Potentially Active Domestic and Stock Wells within a Five-Mile Radius of the Lost Creek Permit Area

Lost Creek drawdowns (HJ horizon) - Rough Calcs based on RAI responses

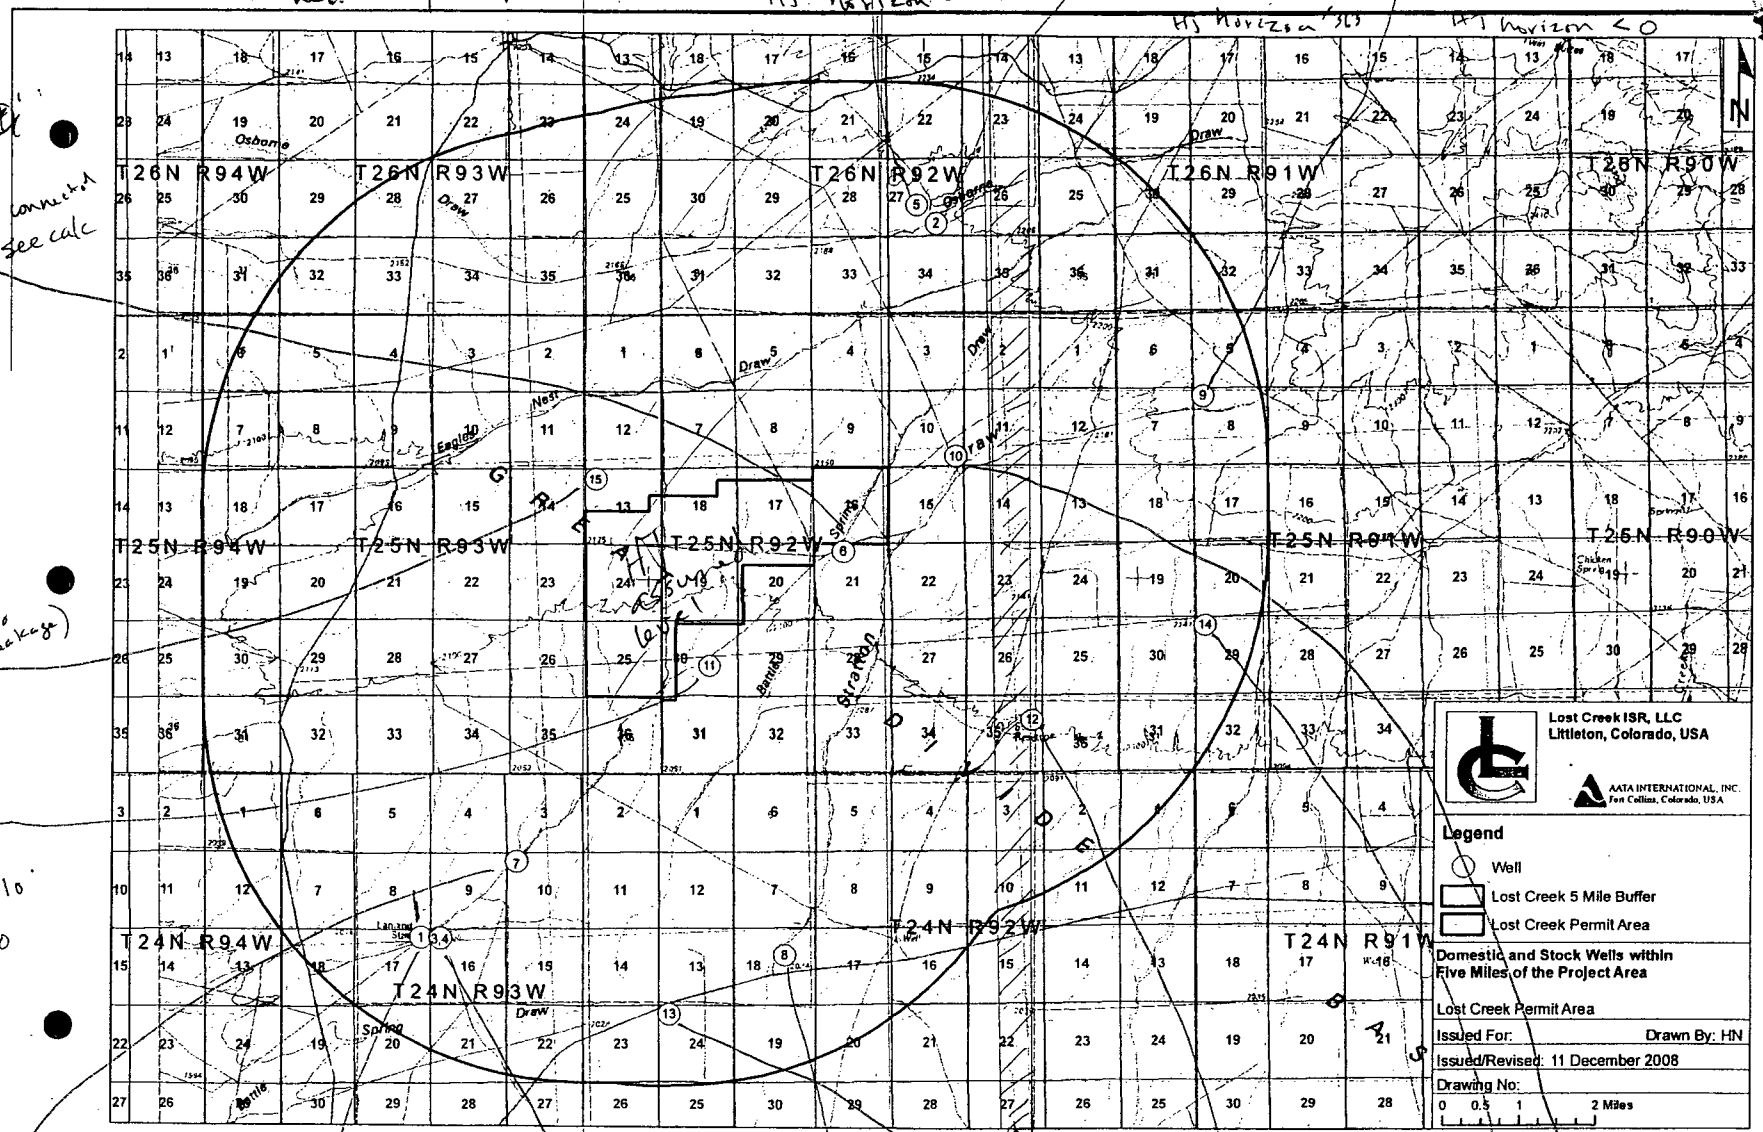
HJ horizon in L-rance Area ~ 370 - 500 deep  
 Top of HT 920' 45'

5. 220 deep -1' static dd = 160'  
 HJ horizon = 133-363  
 2. 280' deep 250' static dd = 160' 137'  
 9. 300' deep 199' static dd = 15'

6. 900' deep 104' static dd = 224' HT horizon ~ 370-500  
 40' HT connect see calc

15. 370' deep 269' static dd = 22' (10% leakage)  
 HJ horizon ~ 370

11. 320' deep 109' static dd = 22' 10'  
 HJ horizon ~ 370

1. 216 depth 60 ft static water dd = 15' 10% HT horizon > 920

3. 600 ft deep -1' static (artesian) horizon = 7920'  
 4. 600 ft deep 60' static HT horizon = 7920'

13. 380 ft deep 140 ft static dd = 15' 10% horizon = 370-500 HT horizon = 0  
 8. 220 ft deep 138 ft static dd = 15' HT horizon = 370-500

16. 290 ft deep 155' static dd = 199' (dry) HT horizon 95-225

HJ horizon outcrop area (based on 30' dip to west)

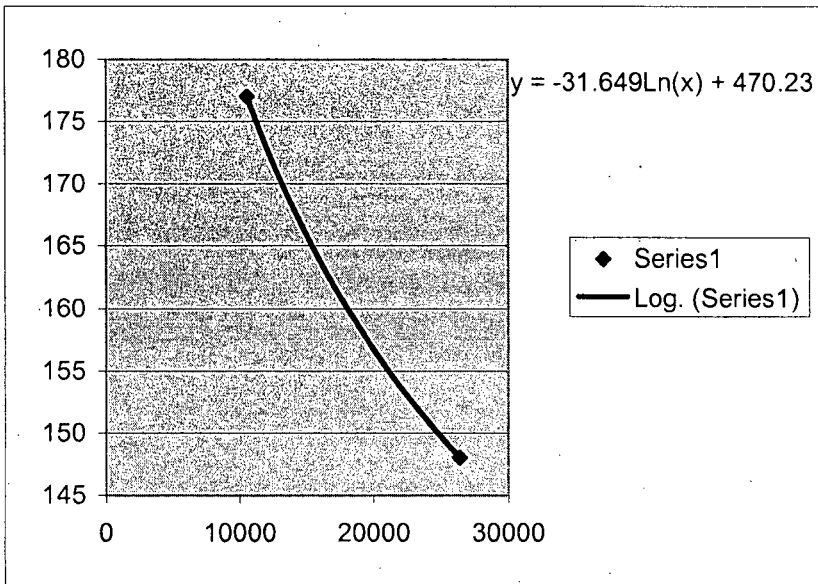
As per ER...  
Avg  
174  
gpm  
over  
8 yrs  
3-13

← Pump rate? - disposal implications  
eg RRI Smith Ranch 300gpm  
↑  
longer sweep = increased surety

Drawdown at site?  
Longer to sweep

Note: Battle Springs formation dips to west at 3°  
Stated in attachment 2.7.1 & Section 2.6.1.2

artificially low transmissivity

(NRC modeling)  
N side of fault  
do realistic model  
Entire thick 7% transmissivity
